Issues with rev1

Title: Subharmonizer Overview

Rev: 1

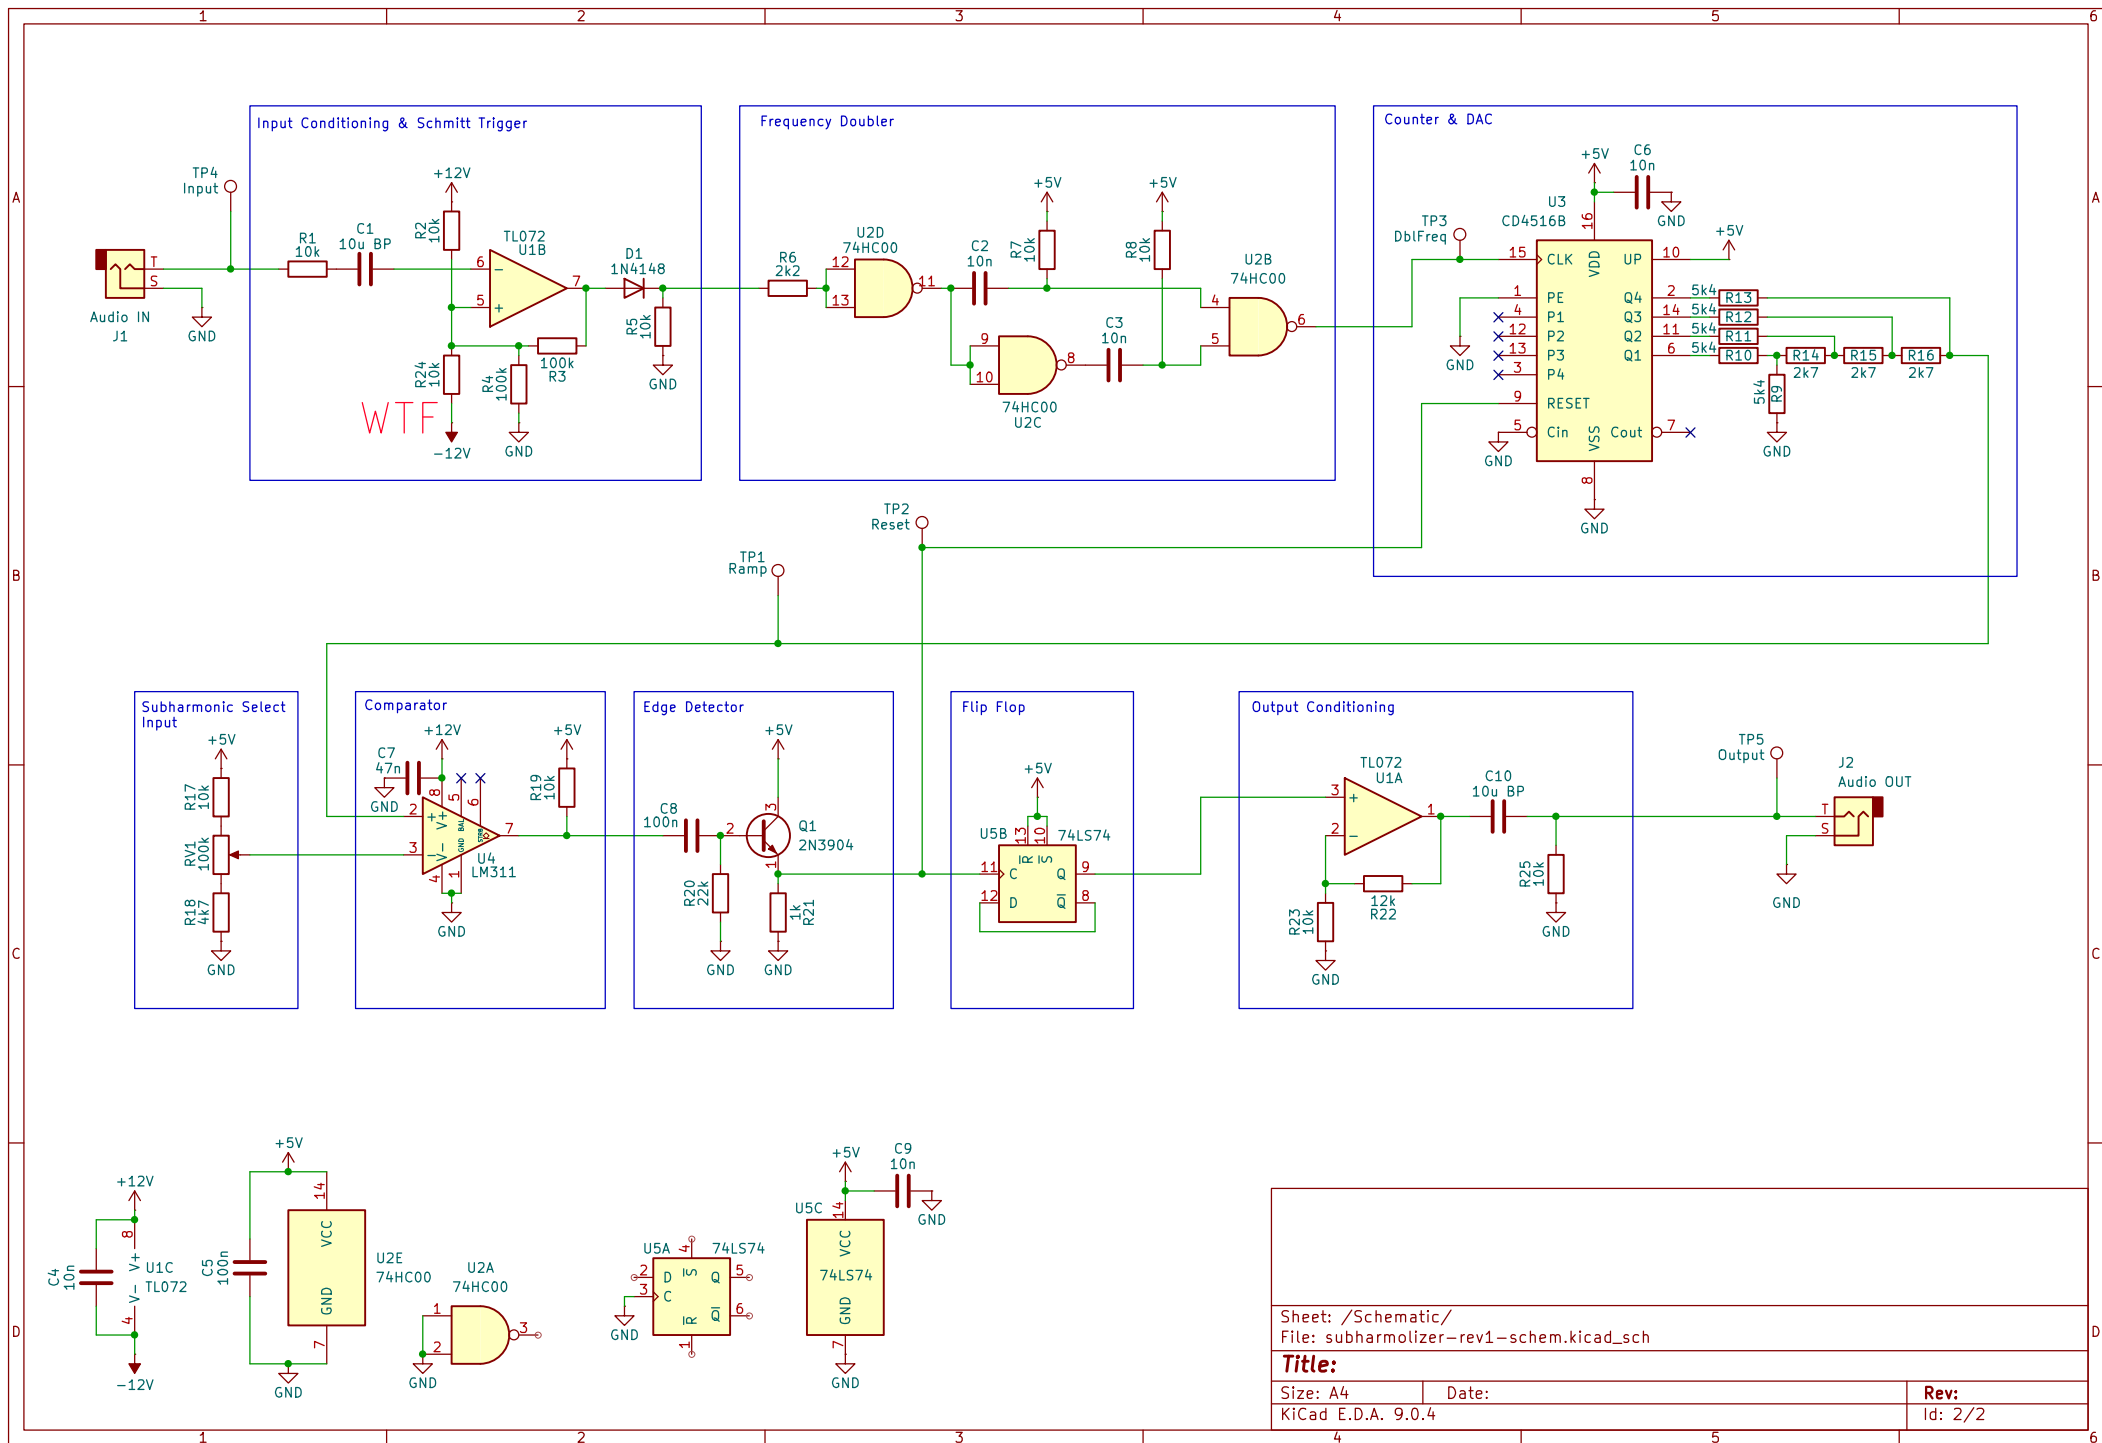
1. needs frontend filter to remove freqs > ~4kHz
(or: the frequency doubler needs tweaking to support higher freqs)
2. output vol seems v low
3. need to add CV override to Threshold input
4. phase of output is unpredictable – freq doubler can see a –ve change before a +ve one
5. bonkersness when Threshold set very close to an exact level coming from D2A
maybe need some hysteresis?
6. might be nice to add a second counter to allow for more subharms
or perhaps use a CD4060 or such instead of CD4516 – we’re not using the preset
7. output square wave has a significant spike on the leading edge
